The Planning Department,
South Dublin County Council,
County Hall,
Town Centre
Tallaght,
Dublin 24

Re: Application: SD21B00526 - Response to request for Additional Information: Decision Order No. 1569, 07-Dec-2021.

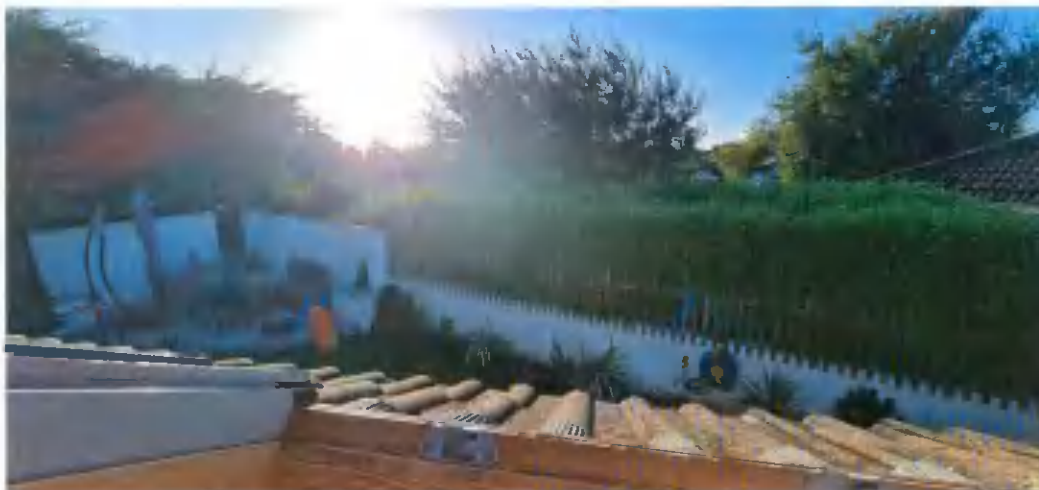
With regards to the overlooking of the property to the southeast, no.17 Oakcourt Park, we once more include a photograph to highlight the fact that currently only very minimal overlooking into no. 17 is possible from the existing SE facing Velux windows due to the existing approximately 3m+ high hedge. The photo below shows the view from the higher floor level in the landing, i.e. the position from which most overlooking is possible.

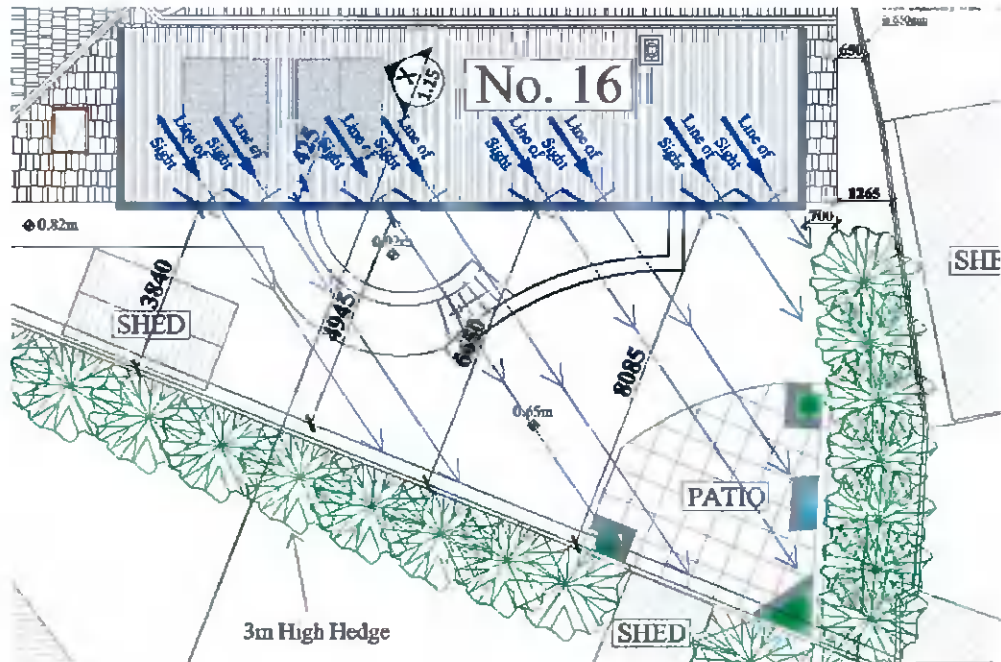
We also note that the distances from the proposed new SE facing first floor windows to the boundary with no. 17 are significantly greater than stated by the Authority in the AD. The actual distances (measured perpendicular to the boundary wall) are approximately 3.8m to 8.1m as opposed to just 1.5m to 4.7m as stated in the AD. This is clearly demonstrated in new drawing, *1.17 – Details of Distances to Boundaries*, an excerpt from which is included below.

As the horizontal distances are significantly greater -any slight adverse impact on "Unnecessary Overlooking" caused by the proposed first floor windows now being located vertically in the new extension side wall of no. 16 is significantly sufficiently mitigated.

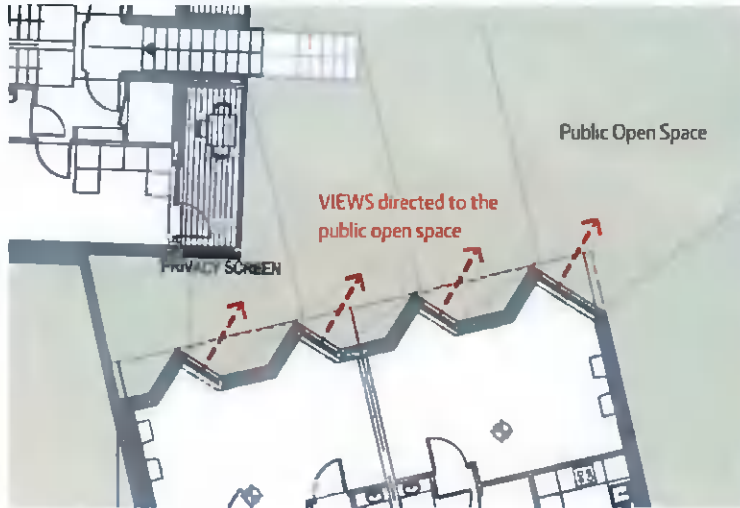
Nonetheless a redesign of the windows has been undertaken to further mitigate against potential unnecessary overlooking should the Authority deem it necessary. This is accomplished by altering the design and as a consequence the orientation of the leaves (panes) of the new windows being set at an angle, with each window having two opaque leaves which do not permit viewing through and two regular transparent clear glass leaves which do permit viewing through. However, the leaves which do facilitate viewing are angled to direct viewing towards the rear of the garden. See extract from drawing 1910-PG-1.10 of one of such windows below:

In our proposal the clear glass leaves (panes) are angled so as to direct the occupant's view further to the rear, which lengthen the viewing distance to the boundary wall and thus reduce the occupant's vertical angle of overlooking.

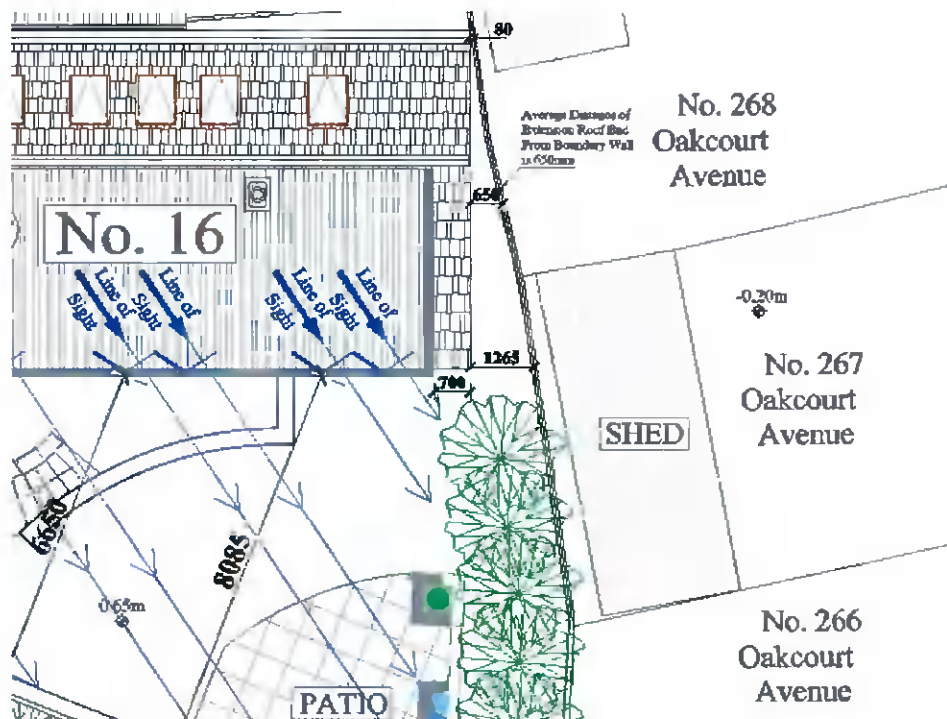
a) With regards to the proposed extension being "considered to be overbearing" on the property directly to the east of no. 16 Oakcourt Park, no. 268 Oakcourt Avenue, the applicants have spoken openly, collaboratively, and amicably with the owners to appraise them of the AD request. The owners have confirmed no objection to the proposal to extend the house close to the shared boundary wall. For their part they have requested some reasonable stipulations which the new design includes (or has always adhered to). This has been memorialised in a formal agreement signed by both the applicants and the owners of no. 268 Oakcourt Avenue. Please find enclosed a letter of agreement between both parties confirming that they have no issues with the proposed works if said conditions are met.

To further demonstrate the counter argument for not adjusting the extents of the rear boundary for the extension we wish to highlight that the new rear gable end is only very close to the rear boundary wall at one corner. Due to the relative angle of the boundary wall, on average the end of the new roof will be an average of approximately 650mm set back from the centre of the boundary wall, as demonstrated in drawing 1910-PG-1.17 – Details of Distances to Boundary shows (excerpt below) – which is already 2/3 of the required set back distance by the Authority.

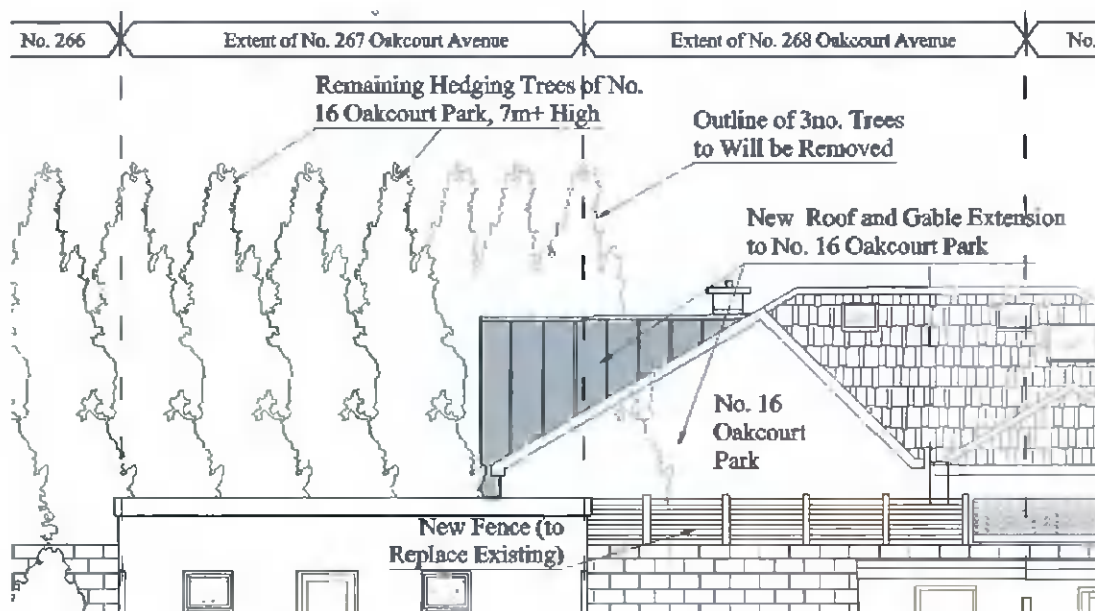
Furthermore, with reference to drawing 1910-PG-1.15 (excerpt below), which contains the rear contextual section, it is demonstrated that the removal of 3no. trees at the rear boundary will in fact open up much more visible sky to the rear. Arguably this positive impact from the removal of the 7m+ trees immediately next to the boundary wall will outweigh any negative impact from the introduction of the 5m or so high extension which is set back from the boundary somewhat as already outlined.
